## Changes from May 2008 meeting:

### 33.4.8.2 Midspan signal path requirements

#### 33.4.8.2.1 Alternative A Midspan PSE Compliance test setup

Figure 33-24-1. Measurement Setup For Alternative A Midspan PSE Transfer Function

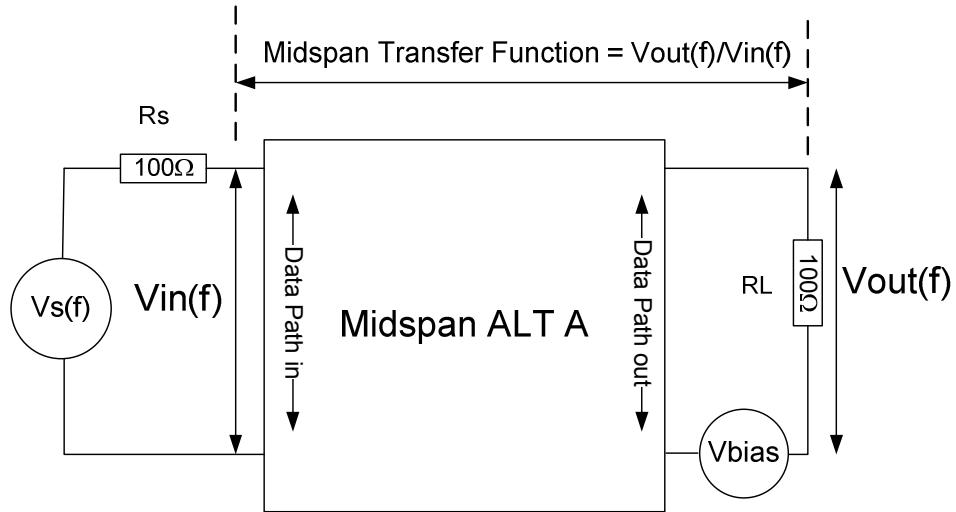
**1. The setup was updated to reflect all types of Midspan implementation (transformers or autotransformers) in order to ensure that the device is tested under DC bias current.**

Compliance testing shall be performed by applying test signal to the Midspan PSE signal input with a source impedance of  $100 \Omega \pm 1 \%$ . The Midspan PSE signal input and output may be connected to a 0.5 m max length of CAT5 cable, terminated with  $100 \Omega \pm 1 \%$ .

The transfer function shall be measured from the output termination to the signal input. See figure 33-24-1.

- $V_{in}(f)$  is the Sine wave signal to be used to measure the Midspan TF.
- $V_{bias}$  is the DC offset voltage to be applied in series to  $R_L$  in order to generate  $I_{bias}$ .
- $V_{out}(f)$  is the Midspan response to  $V_{in}(f)$
